ARCHITECTURAL REVIEW BOARD STAFF REPORT

Project #/Name	SP-2023-19: Stonefield Tesla Outdoor Sales, Storage and Display
Review Type	Advisory Review for a Special Use Permit
Parcel Identification	061W00300019A0
Location	Four parking spaces along the northeast elevation of the building at 1951 Swanson Dr. and six parking spaces along the southeast elevation of the building at 1954 Swanson Dr. (See Fig. 1 and Attach. 1.)
Zoned	Neighborhood Model District (NMD), Entrance Corridor (EC)
Owner/Applicant	OCT Stonefield Property Owner LLC/Woods Rogers Vandeventer Black (Steve Blaine)
Magisterial District	Jack Jouett
Proposal	To establish outdoor sales, storage and display of vehicles associated with a Tesla vehicle sales office. (See Attach. 2.)
Context	The immediate context is the Stonefield Town Center.
Visibility	The parking spaces proposed for sales, storage and display are existing spaces in existing parking lots. They are visible from the Entrance Corridors but aren't readily distinguishable from nearby parking spaces. (See Figs. 2 and 3.)

ARB Meeting Date	January 16, 2024
Staff Contact	Margaret Maliszewski

Fig. 1: Left: Location of proposed outdoor sales, storage and display parking spaces within the Stonefield Town Center. Right: Proposed Tesla parking plan.

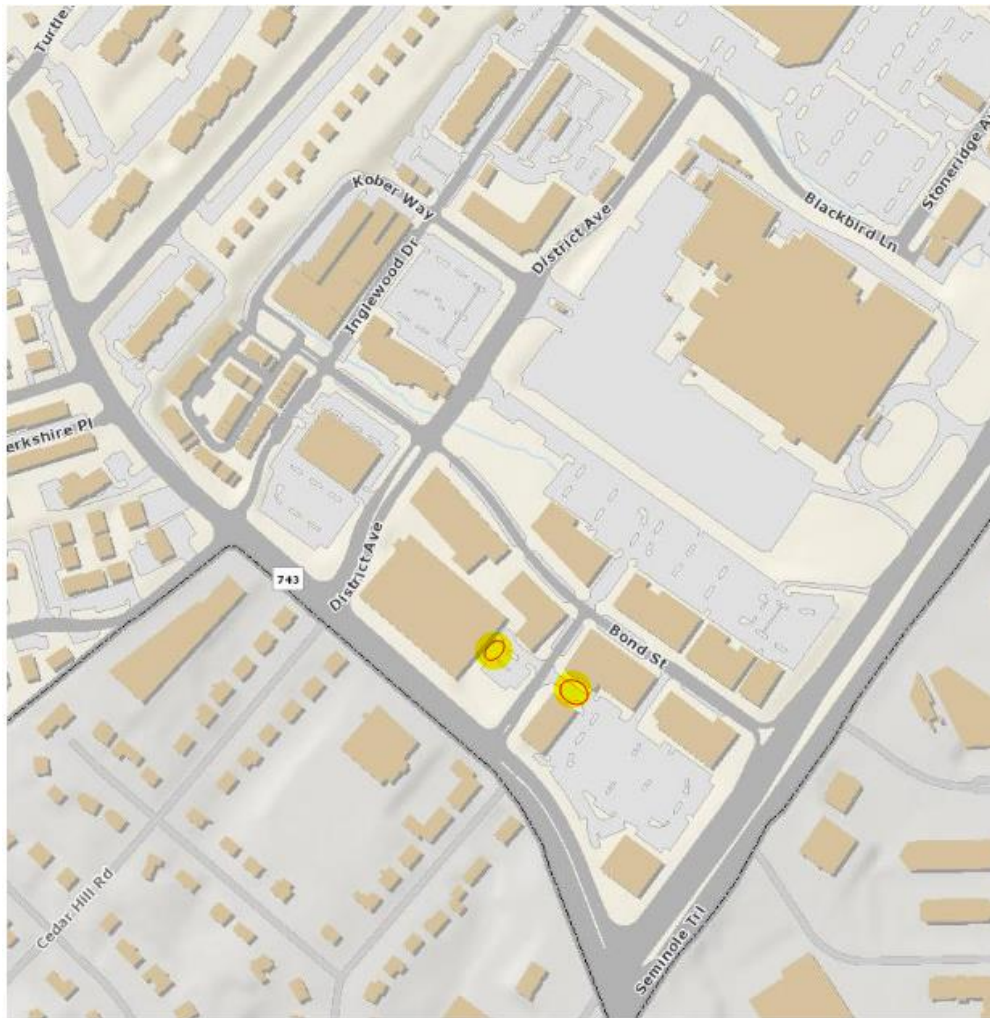
REF	GUIDELINE	ISSUE	RECOMMENDATION
	<i>Purpose</i>		
1	The goal of the regulation of the design of development within the designated Entrance Corridors is to ensure that new development within the corridors reflects the traditional architecture of the area. Therefore, it is the purpose of ARB review and of these Guidelines, that proposed development within the designated Entrance Corridors reflect elements of design characteristic of the significant historical landmarks, buildings, and structures of the Charlottesville and Albemarle area, and to promote orderly and attractive development within these corridors. Applicants should note that replication of historic structures is neither required nor desired.	The proposed use would not alter the layout of the site, the orientation of buildings, pedestrian or vehicular connections, open spaces, or views around the site. The sales office is proposed to be established in an existing building whose architecture was previously approved by the ARB. Proposed changes to the exterior of the building are not expected to be visible from the EC street. (Attach. 4) The parking spaces that would be used for outdoor sales, storage, and display already exist. The appearance of those spaces would not change from the current condition.	Staff recommends approval of the proposed outdoor sales, storage, and display in the existing parking spaces noted in the Tesla Parking Plan with the standard conditions for this use, including parking only in striped spaces and no elevated vehicles.

2	Visitors to the significant historical sites in the Charlottesville and Albemarle area experience these sites as ensembles of buildings, land, and vegetation. In order to accomplish the integration of buildings, land, and vegetation characteristic of these sites, the Guidelines require attention to four primary factors: compatibility with significant historic sites in the area; the character of the Entrance Corridor; site development and layout; and landscaping.	There are some characteristics of sales, storage and display parking that typically contribute to negative visual impacts. These include vehicles parked for longer and more continuous periods of time as compared to customer and employee parking, and a layout that parks vehicles in stacked rows and closer together than customer and employee parking. These issues are not present with this proposal because the layout is the existing customer parking, the number of display spaces is minimal, and visibility of the spaces from the EC streets is limited. Consequently, orderly development will be maintained, and the character of the EC will not change.

1. Use of this site must be in general accord with the Tesla Parking Plan. To be in general accord, vehicles for sales, storage and/or display must be parked only in the spaces indicated for sales, storage and display on the Tesla Parking Plan.
2. Vehicles for sales, storage and/or display must be parked in striped parking spaces.
3. Vehicles must not be elevated anywhere on site.
